STAFF REPORT

HEARING DATE: 9/17/2020
TO: Mayor & City Council
FROM: Joe Dodson, Associate Planner
208-884-5533
SUBJECT: H-2020-0067
Jocelyn Park Subdivision

Request for Preliminary Plat approval of 67 single-family residential lots and 7 common lots in an existing R-8 zoning district.

A. Preliminary Plat (dated: ~~July 17, 2020~~ 9/08/2020)

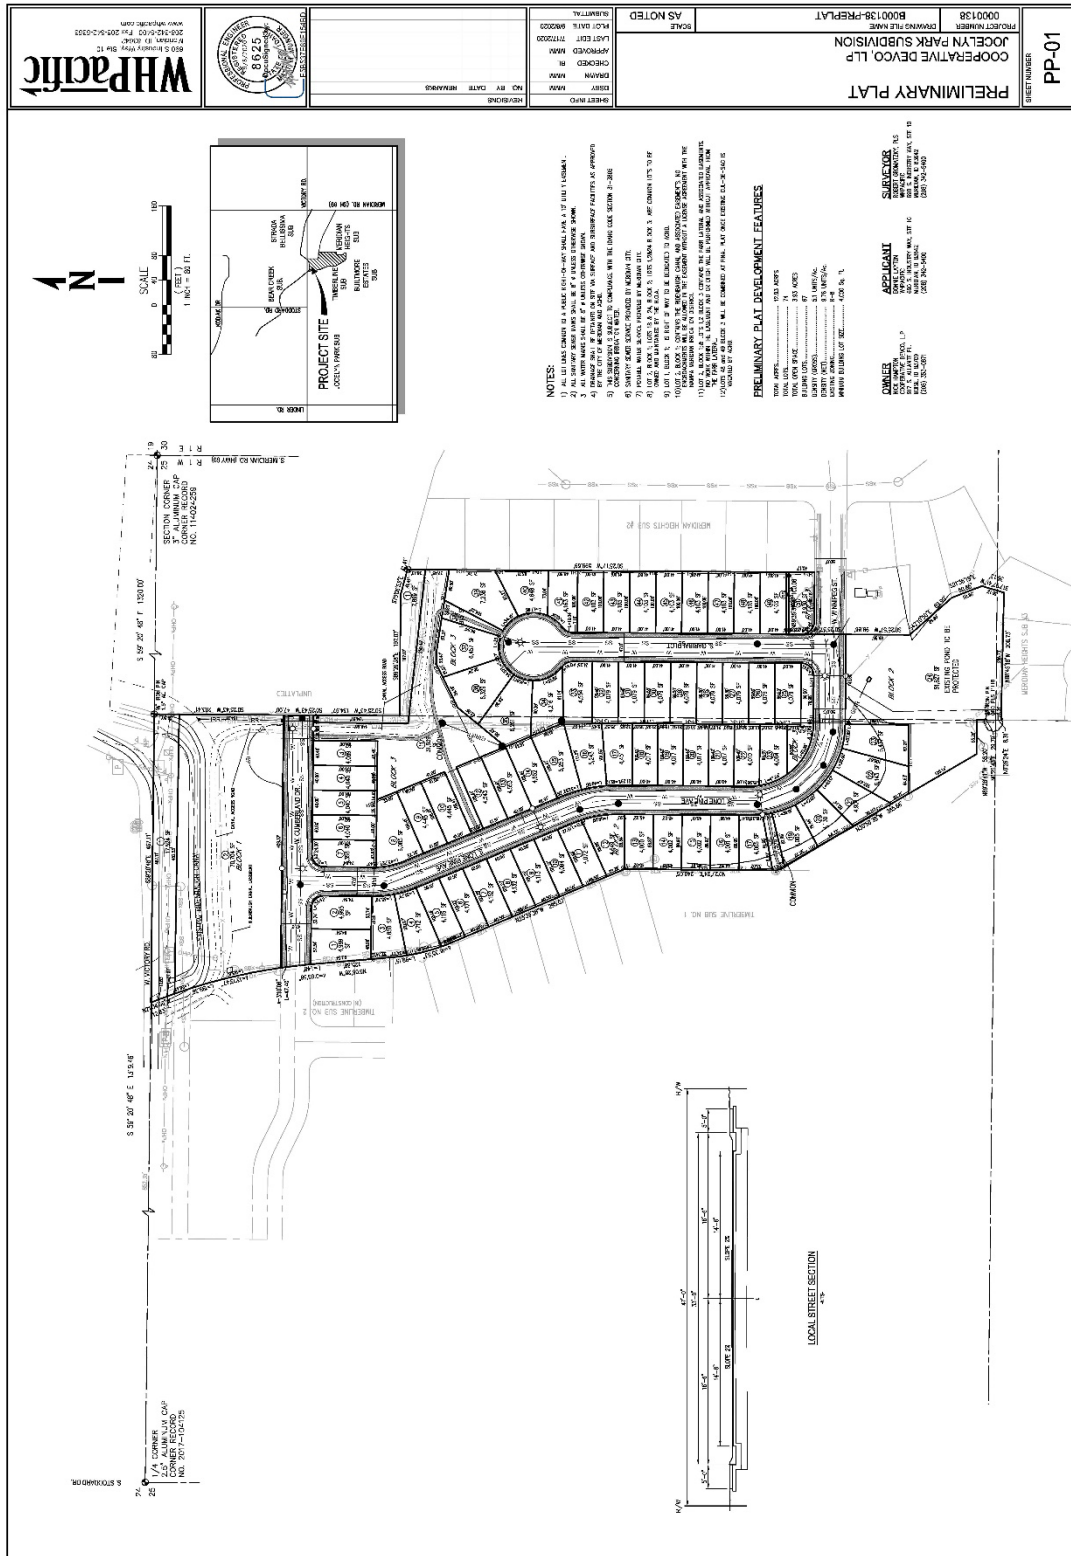
1. The preliminary plat included in Section VII.A, dated July 17, 2020, shall be revised as follows at least ten (10) days prior to the City Council hearing:

- a. ~~Revise the plat to include some of the area behind~~ rotate Lots 35-37 and 36, Block 3 to the west and subsequently move the proposed micro-pathway to the east to make the open space area behind them more usable and accessible, as part of these building lots instead of common open space up to the boundary of the irrigation district easement.

- b. ~~Revise the plat to show the micro-pathway to be located between Lots 10 & 11, Block 3 instead of between Lots 12 & 13, Block 3.~~
 - c. Revise the plat to show the additional right-of-way along W. Victory Road as required by ACHD; this should include a 5-foot wide sidewalk located at least 31-feet from centerline.

OPEN SPACE EXHIBIT

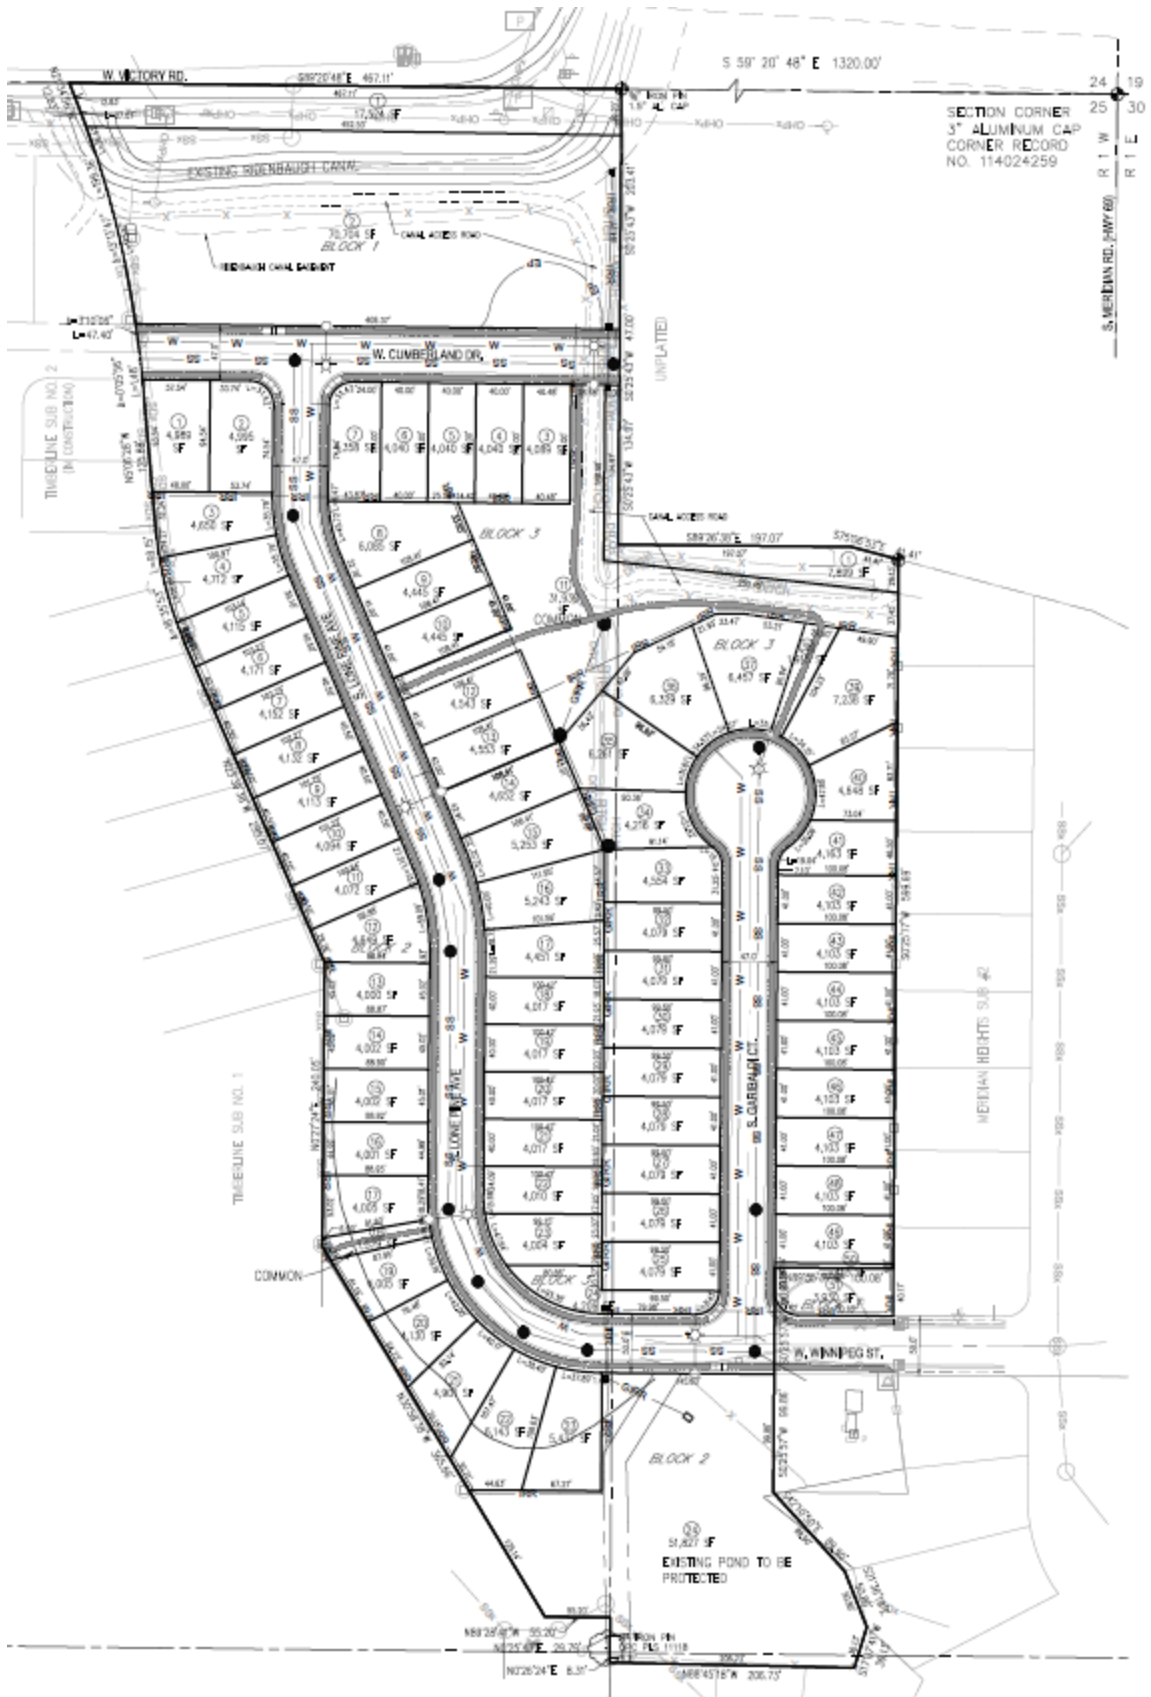
According to the open space exhibit (see Exhibit VII.B), the applicant is proposing a total of 3.65 acres of open space. The exhibit shows three (3) distinct areas of open space: one area in the south that contains the pond; one area along the entire northern boundary of the subject site; and one centralized area. The large open space lot containing the pond abuts open space area in the Timberline No. 1 subdivision currently under construction. In addition, there is an end cap lot and a micro-pathway connection to the west shown on the open space exhibit. The submitted open space exhibit shows all of this area as qualifying but upon Staff's review, some of this area is not qualifying.

The existing pond is more than 25% of the lot in which it resides and therefore the entire lot is not qualifying open space per the standards listed in UDC 11-3G-3B.7. The other area of open space that is listed as qualifying but is indeed non-qualifying is the end cap lot located at the south end of the lot (approximately 4,200 square feet) directly north of the pond. This area meets neither the 50' by 100' dimensions nor the 5,000 square foot minimum size in order to count towards the qualified open space. After removing the end cap lot and the lot containing the pond from the open space calculations, there are 2.46 acres of area that is all qualifying open space. Staff is recommending a condition to revise the open space exhibit prior to the City Council hearing to ensure a clean record.

An area of additional concern for Staff is the open space area directly north of Lots 35-37, Block 3 (the lots at the end of S. Garibaldi Court in the eastern half of the site). The Applicant is proposing to leave an area of open space between the rear yards of these three homes and the irrigation district access road. The access road must be fenced off from this development which leaves a thin area behind homes with the only true visibility coming from the open vision fencing of these three homes' rear fence. This area leads to nowhere and does not appear to offer any usable benefit for the development if left as is. Even with the required open vision fencing along the rear of these lots, Staff is concerned this area of open space will be neglected due to the slope of the terrain and its location. Therefore, Staff is recommending that this area be added to the adjacent lots, Lots 35-37, Block 3, instead of remaining open space. The open space calculations should then be revised to remove this area from the calculations table.

3. The Open Space Exhibit and calculations table shall be corrected as follows at least ten (10) days prior to the City Council hearing:
 - a. Revise the calculations table to show the correct amount of qualified versus non-qualified open space in accord with UDC 11-3G-3.

- b. ~~Revise the open space exhibit to show and calculations table to remove that area behind~~ Lots 35-37 and 36, Block 3 rotated to the west and the micro-pathway relocated to the east to match the revised preliminary plat layout up to the boundary of the irrigation district easement.

- c. Revise the open space calculations to remove that area where the required temporary turnaround is located on the common open space lot, Lot 2, Block 1.
